Correction # 1:

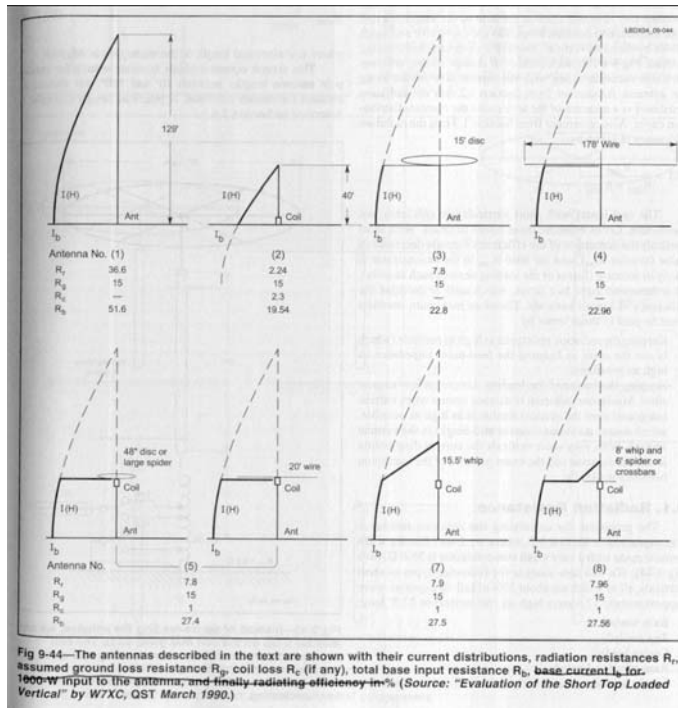
Replace Fig 9-44 with the following . . .
